NEWS FLASH!!!

To all owners of Freightliner and Western Star Class 8 trucks with Detroit Diesel engines!!!

Upgrade your starter to Mitsubishi Electric!

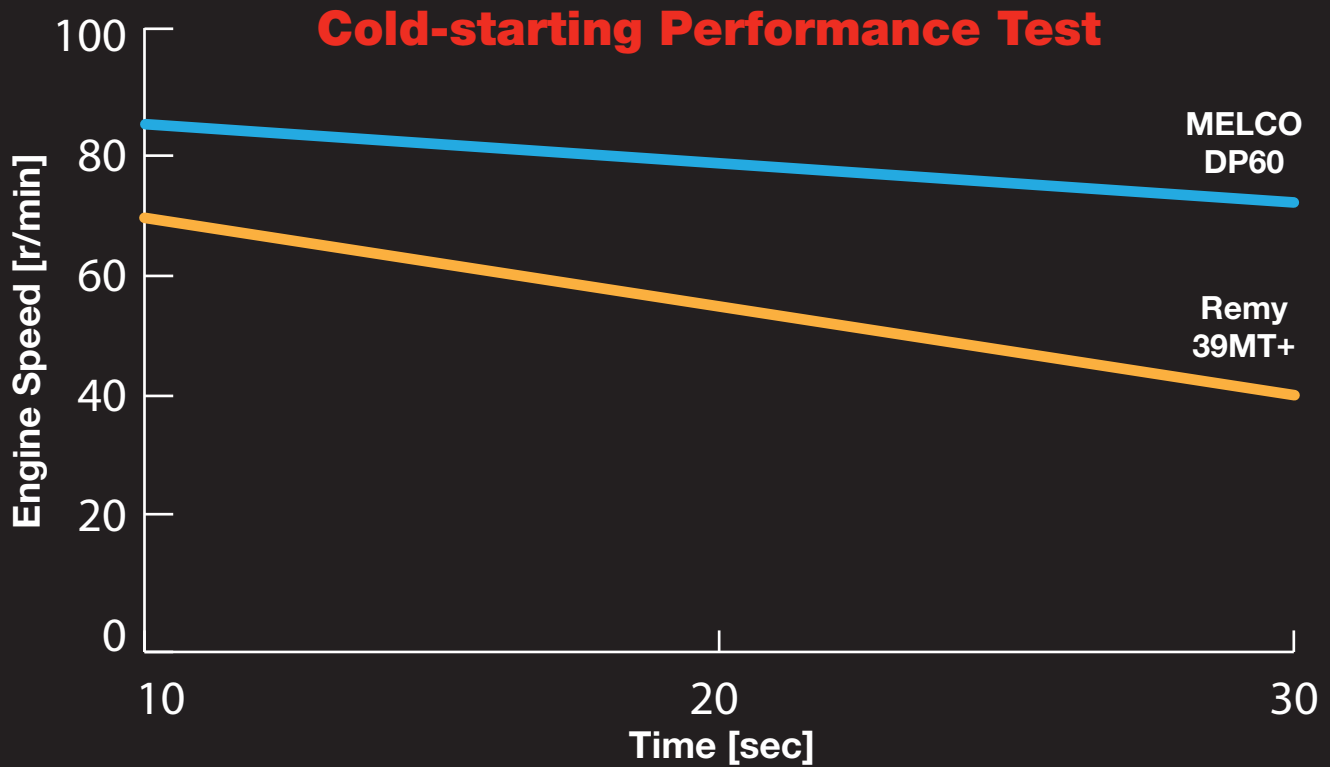
The number of teeth on the GHG17 Detroit Diesel 13/15/16 engines has changed. FL0189 can no longer be used with these new engines. The NEW Diamond Gard Part number for these GHG17 engines is FLA579.

The starter housing and box will have a color coded label for easy identification:

For use on 2015 or older DD13/15/16 engines with 160 tooth ring gear ONLY – any other use will damage unit.

For use on 2016 or newer DD13/15/16 engines with 150 tooth ring gear ONLY – any other use will damage unit.

FL0189

FLA579
